CHANGE ORDER

Project Name: **Haverhill Consentino Middle School** CO No. **05**

Architect's Project No. **21-0818**

PROPOSAL REQUEST

ONE VERTICAL BRACE 34VB27

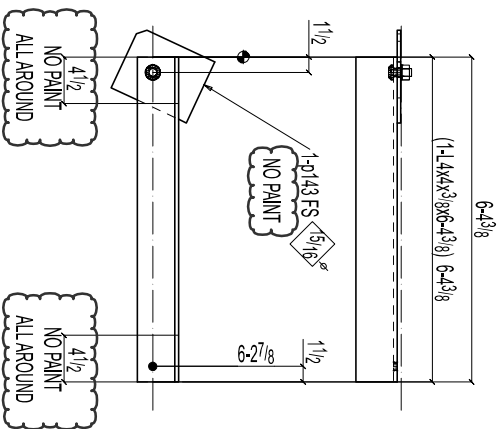
Not reviewed. Could not find piece location on Framing plans or Sections. GC to coordinate

JD-56

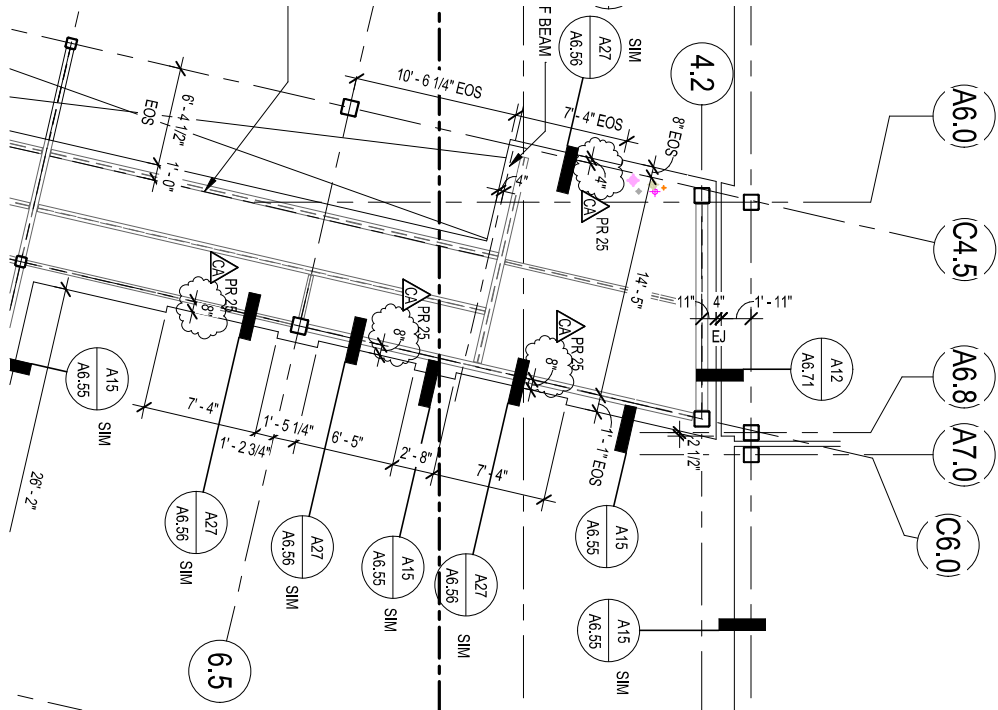
At Sheet A0.23, Level 2 HCP – Area C – revise Edge of Deck at Connector B, along grids C4.5, and C6.0 as shown on attached sketch **JD-56** to coordinate with submitted curtain wall mullion sizes and reviewed steel shop drawings.

L1.01, L1.04, L1.05, L4.07

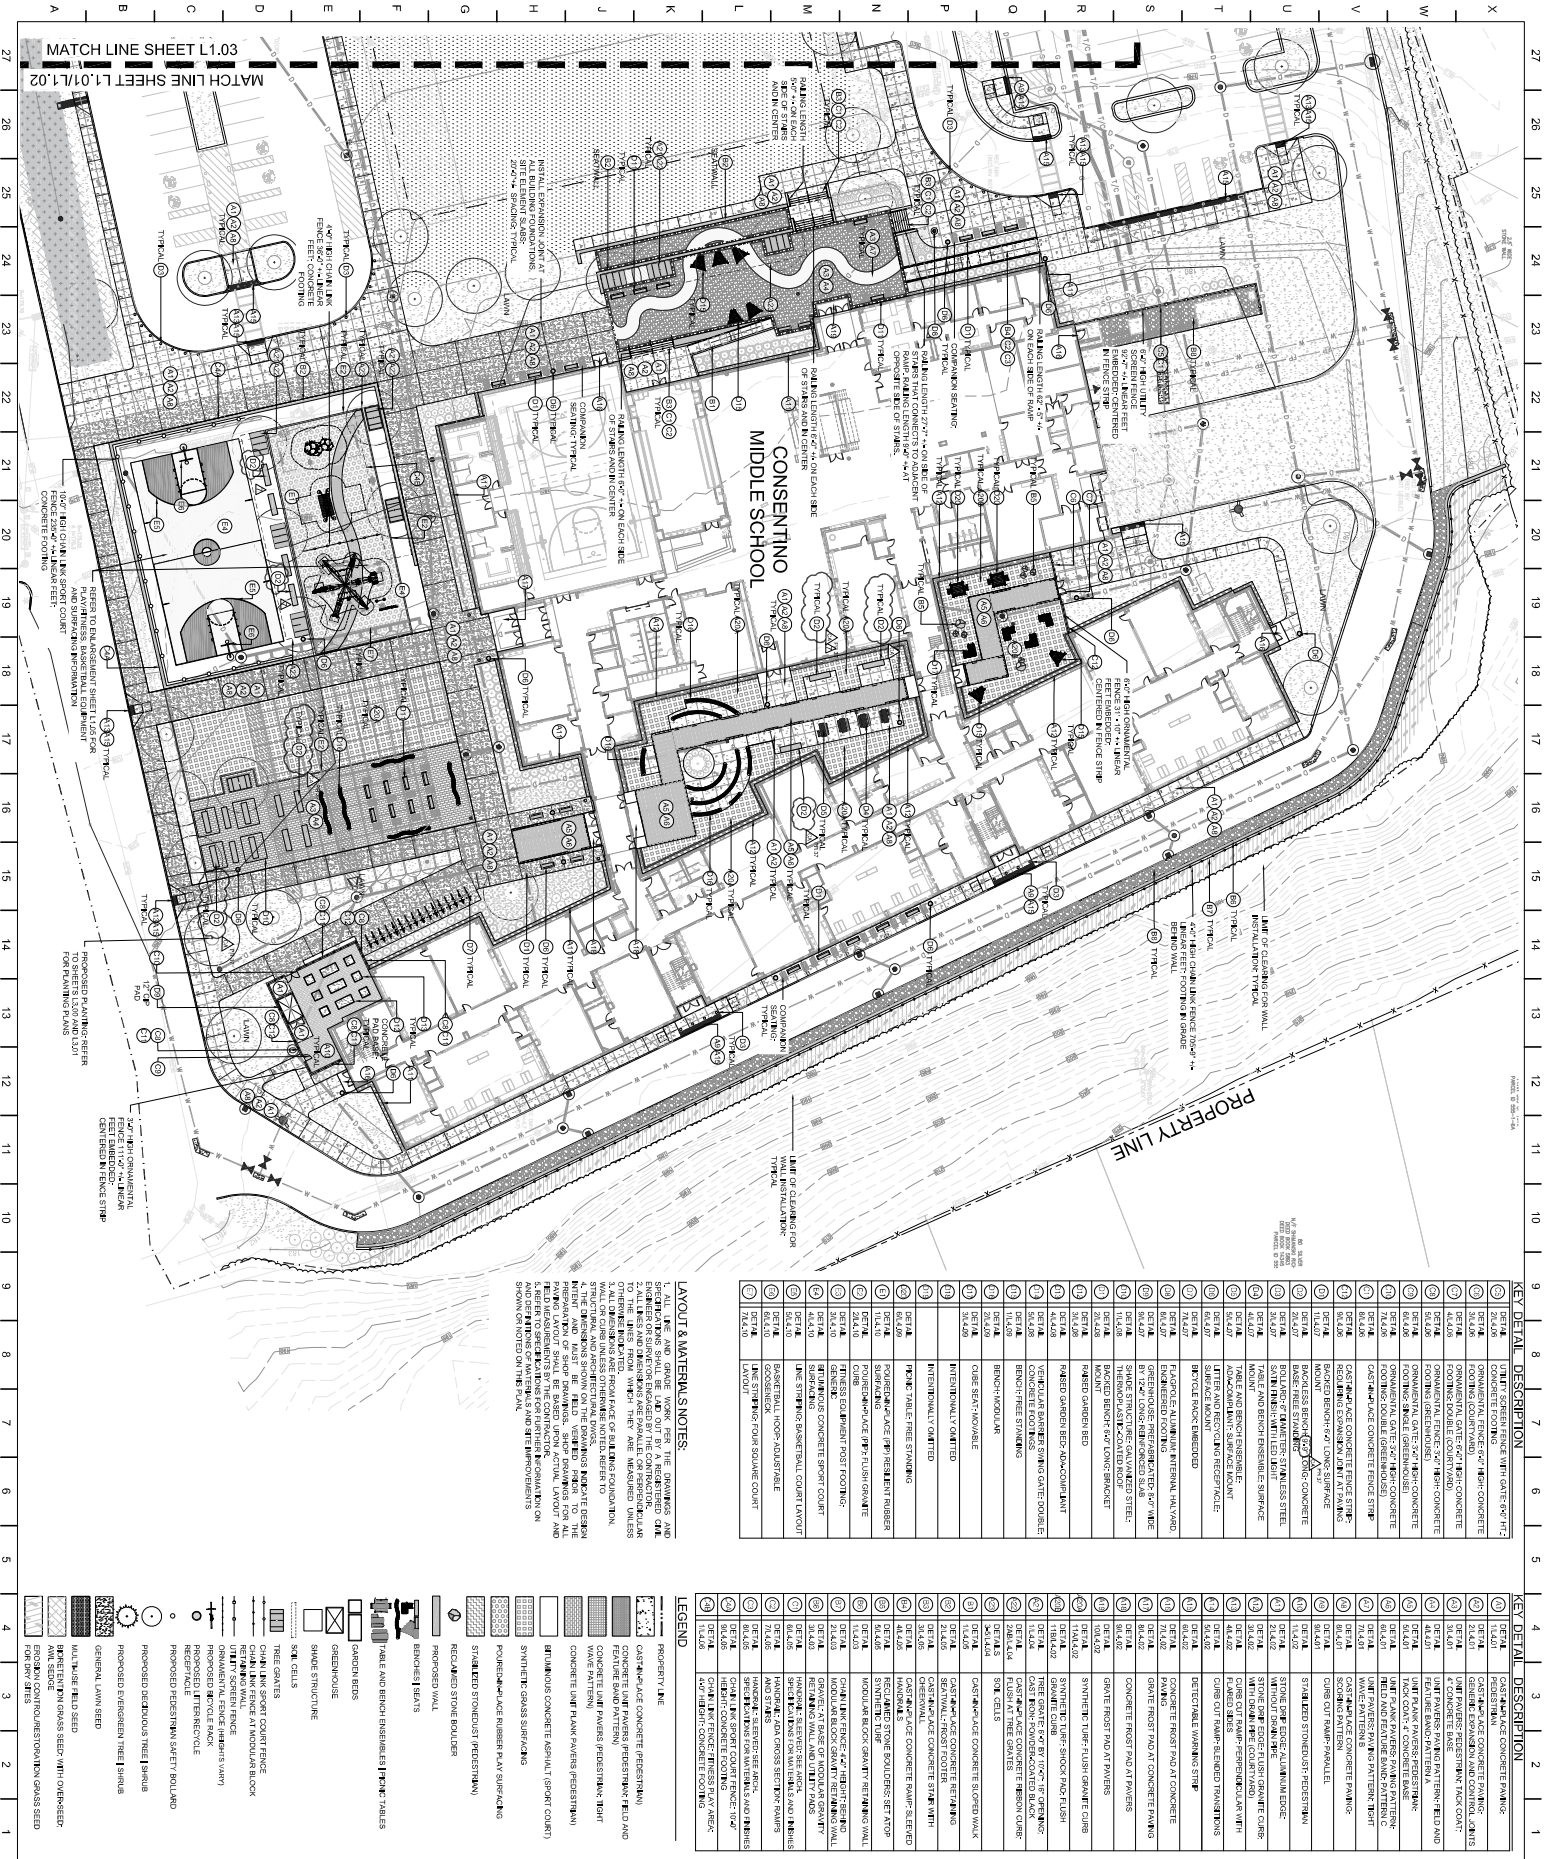
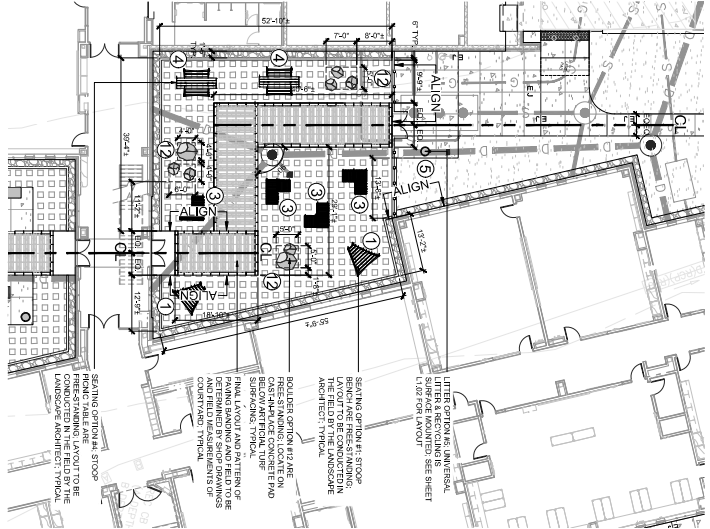
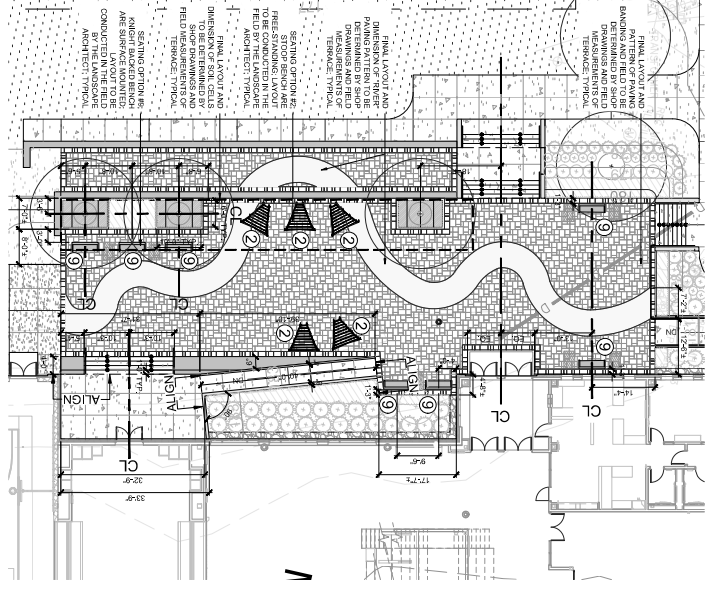
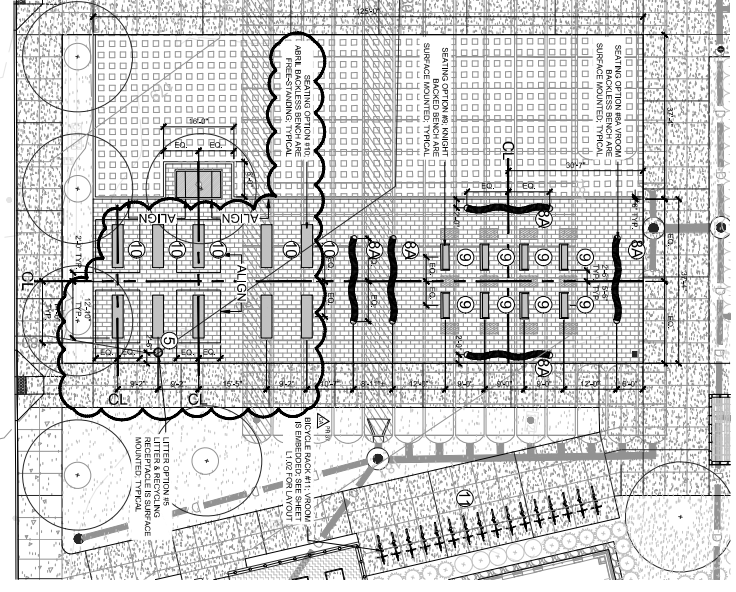
- L1.01** – Material key has changed to reflect revised 9'-0" bench length
Clouds added to indicate that backless benches - key item 'D2' - have changed location
- L1.04** – Abril benches in the South Courtyard and Arrival Courtyard have layout dimension changes
Backless bench product image (10) has been changed to show the Abril bench.
- L1.05** – Abril benches in the Play/Fitness Sport Court area have layout dimension changes.
- L4.07** – Freestanding backless bench detail and product image have been changed to the Abril bench.
